Office Action Summary

10/673,643

MASSEY ET AL.

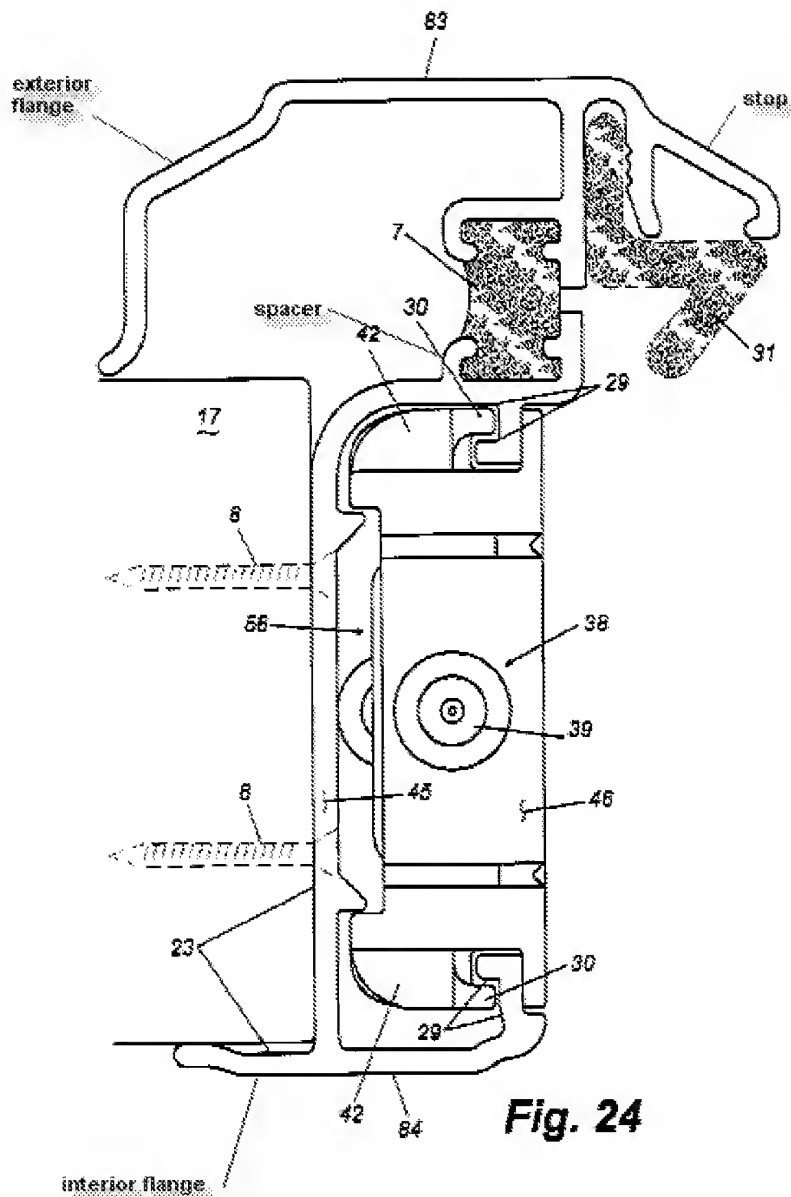
interconnected between said exterior portion and said side portion, an interior flange (labeled below) extending away from where said interior portion meets said side portion to engage the interior surface of the passive door when the astragal assembly is affixed thereto, and an exterior flange (labeled below) opposite said interior flange and extending away from where said exterior portion is connected to said gasket 7 to engage the exterior surface of the passive door when the astragal assembly is affixed thereto, wherein an elongated open channel is defined in the frame with sides formed by the exterior portion and the interior portion and a base formed by the side portion, the elongated open channel having an opening extending between the exterior portion and the interior portion and opposed to the side portion; and an insert 25, 46 (see figure 2) retained within the elongated open channel in the frame, a stop (labeled below), a second gasket 31, a thermal break 7, hooks 29, a strike plate 21. Massey et al. is silent concerning a spacer and a wooden insert.

However, Davis, in figure 4, discloses an astragal 15" comprising a spacer 28" having a distal end 60" protruding outwardly from a major surface (not numbered, but shown in figure 4) of a side portion in a direction that is substantially parallel to an interior flange 20" and substantially perpendicular to said major surface.

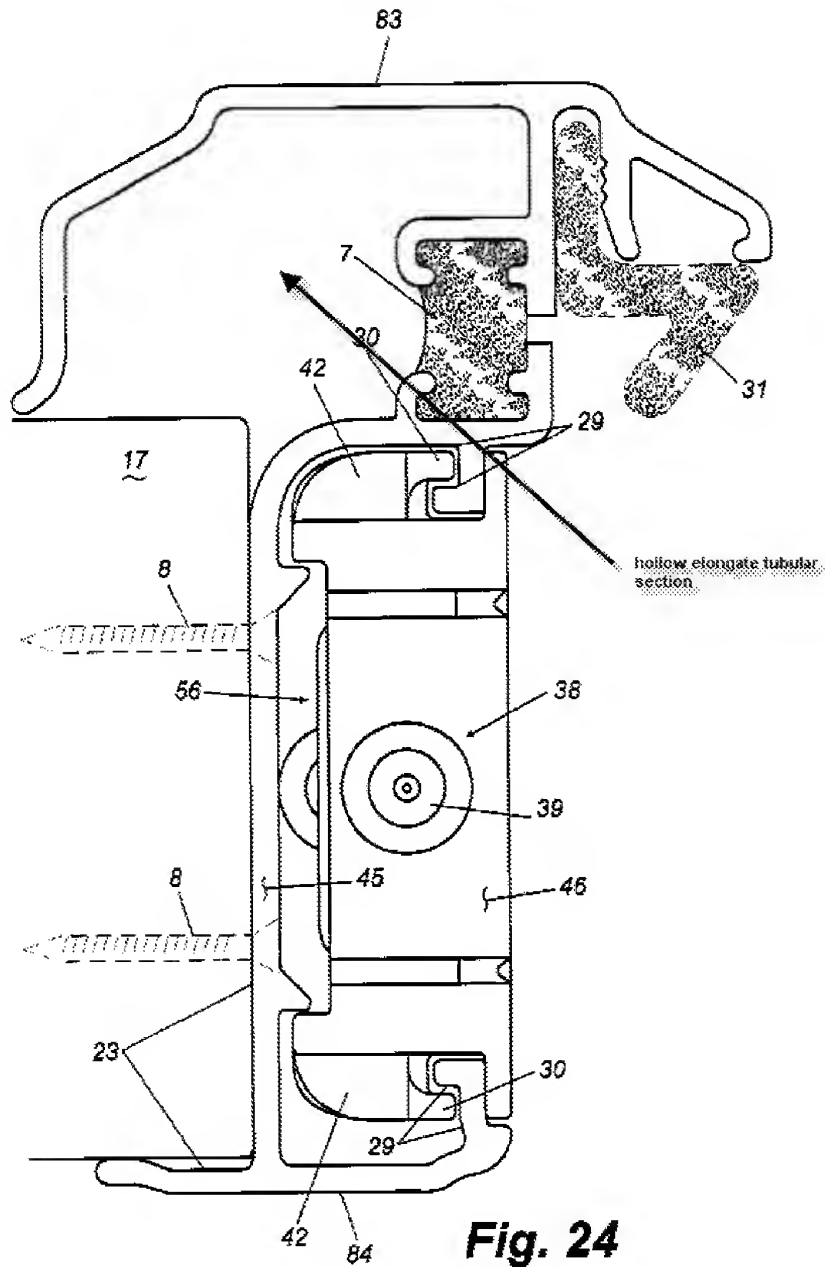
Regarding the applicant's comments concerning Davis, the examiner respectfully disagrees. It should first be noted that claim 1 is only reciting the subcombination of an astragal assembly. Thus, the combination of references only need be capable of attaching to a passive door and only need be capable of performing as the applicant has recited. Davis, in figure 4, discloses a spacer 28" since it spaces the plate 18" away from the door jamb J. The spacer 28" prevents an outer edge of the door jamb J from contacting a major surface of the plate 18" and allows air to flow between the outer edge of the door jamb J and the plate 18" since it creates a space between the door jamb J and the plate 18". Clearly, the spacer 28" is capable of performing the functions recited by the applicant. The fact that the spacer 28" does not come into contact with a door is not persuasive because the applicant is only claiming the subcombination of an astragal. The applicant's comments concerning an astral frame assembly being secured to the top and bottom frames of a door is inaccurate. An astral is defined as a narrow, convex molding, often having the form of beading, The American Heritage Dictionary of the English Language, 1973. Thus, an astragal is not limited to being related to a door and definitely is not, by definition, required to be attached to a door. Moreover, an astragal can be attached to a door frame or any other structure since what an astragal is attached to does not determine if it is or is not an astragal.

Regarding the applicant's comments concerning Hendrickson et al., the examiner respectfully disagrees. Astragals are often attached to wood structures. Thus, one of ordinary skill in the art would be motivated to construct the insert 25 (see figure 2) of Massey et al. from wood so that the insert would match the wood of the structure to which the astragal is attached. Additionally, it should be pointed out that claim 1 does not require any hardware. The hardware is not recited until claim 8. Moreover, simply attaching hardware, such as a strike plate, would not destroy the overall improvement in the appearance of the insert when constructed of wood. Finally, the examiner is not picking and choosing elements from Hendrickson et al. In fact, the examiner is not picking any element from Hendrickson et al. Rather, the examiner is merely stating that is would have been obvious to one of ordinary skill in the art to make the insert 25 of Massey et al. from wood for the reasons proffered by Hendrickson et al.
